Architectural Review Committee Staff Report
Meeting Date: June 17, 2025

PETITION: Product Architectural Change Recommendation

REQUEST: Petitioner requests a recommendation on changes to the previously approved architectural product types for Colonnade Section 4, in advance of a proposed PUD Amendment.

Proposed Elevation: Five-Unit Craftsman

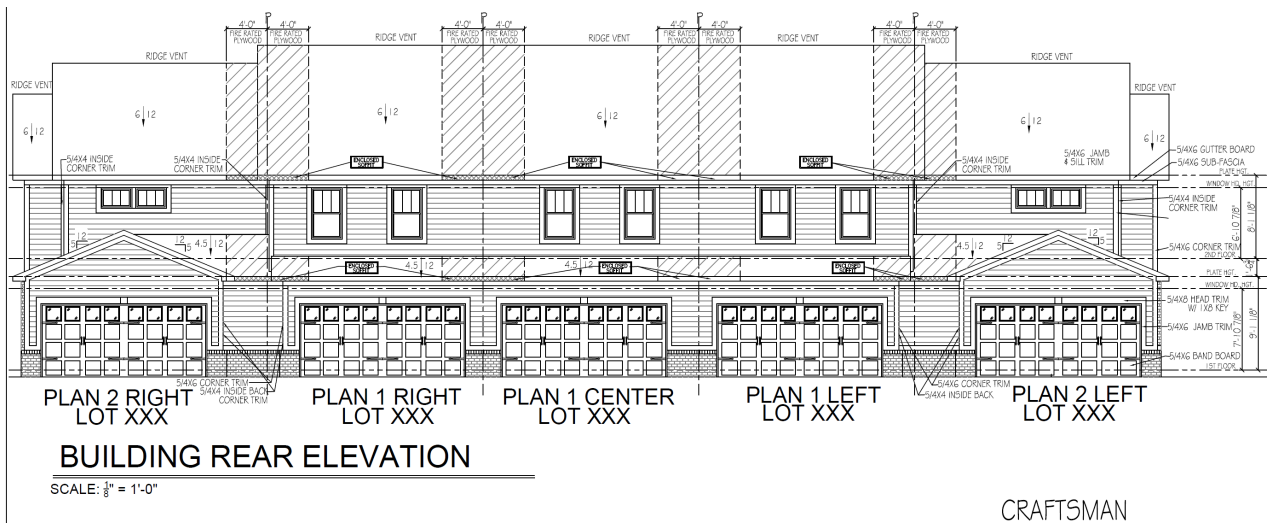
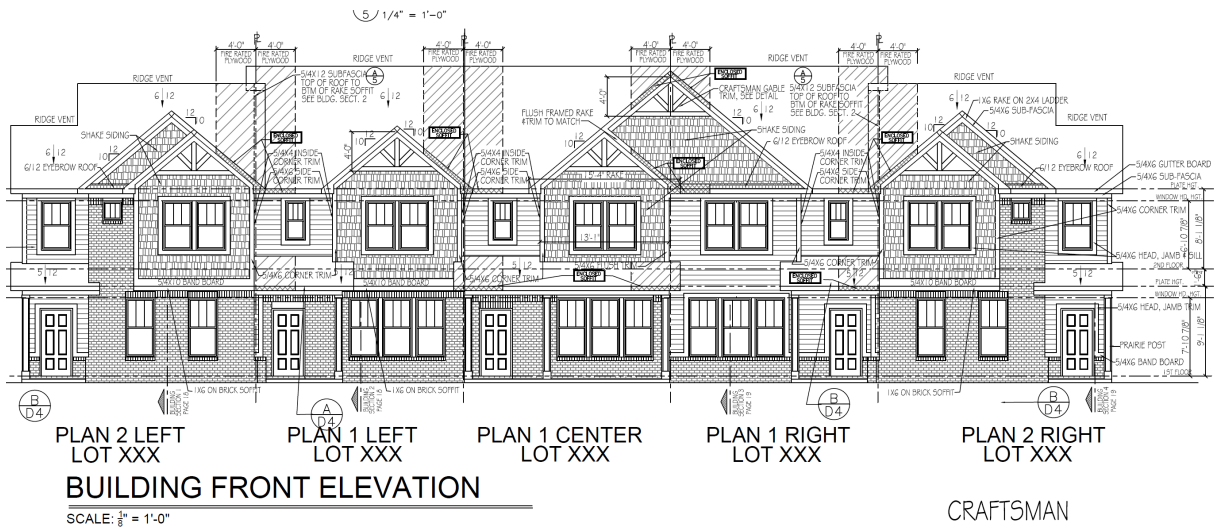
- **Brick Requirement:** The front elevations do not appear to meet the PUD's 50% brick requirement. However, the ARC may approve

alternative treatments if they are found to be architecturally consistent with the overall style.

- **Rear Window Requirement:** The rear elevations do not appear to meet the PUD requirement of three windows per unit.
